Technical Service Information

FORD AX4S/AX4N NO REVERSE

Figure 1

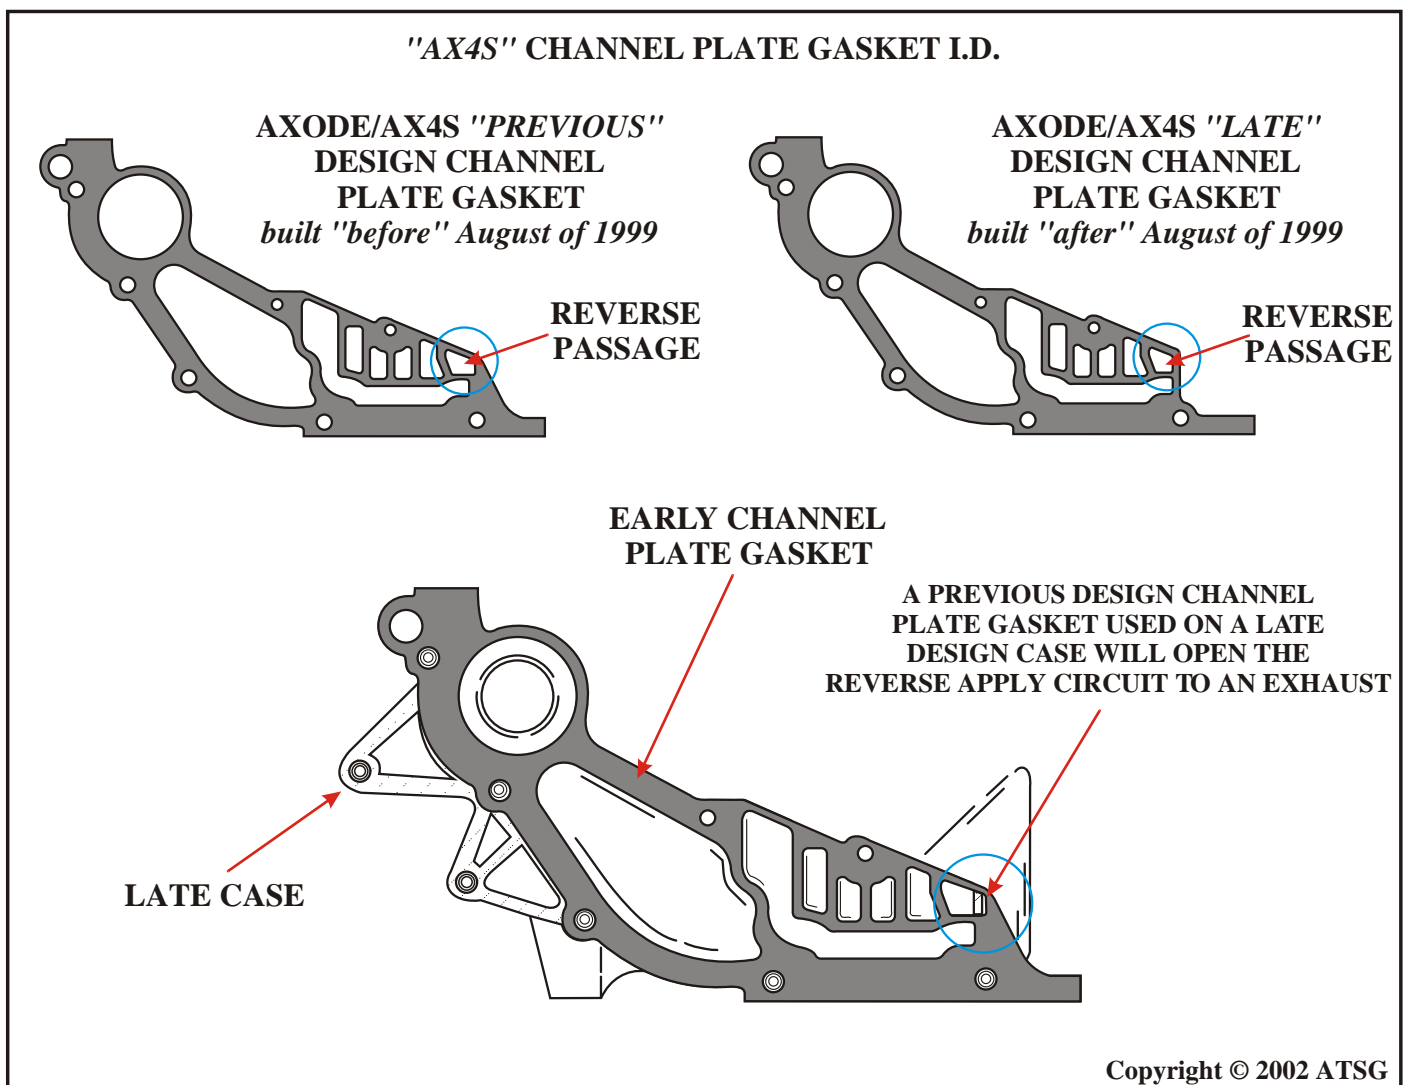
CAUSE: The cause may be, that the *Previous Design* Channel Plate Gasket, was used on a *Late Design* case as shown in Figure 1. When this happens, Reverse apply pressure will be exhausted back into the case because of the gasket hanging over the case casting.

CORRECTION: AX4S-Refer to Figure 1 to identify the correct Channel Plate Gasket for the application of vehicle you are working on.
AX4N-Refer to Figure 2 to identify the correct Channel Plate Gasket for the application of vehicle you are working on.
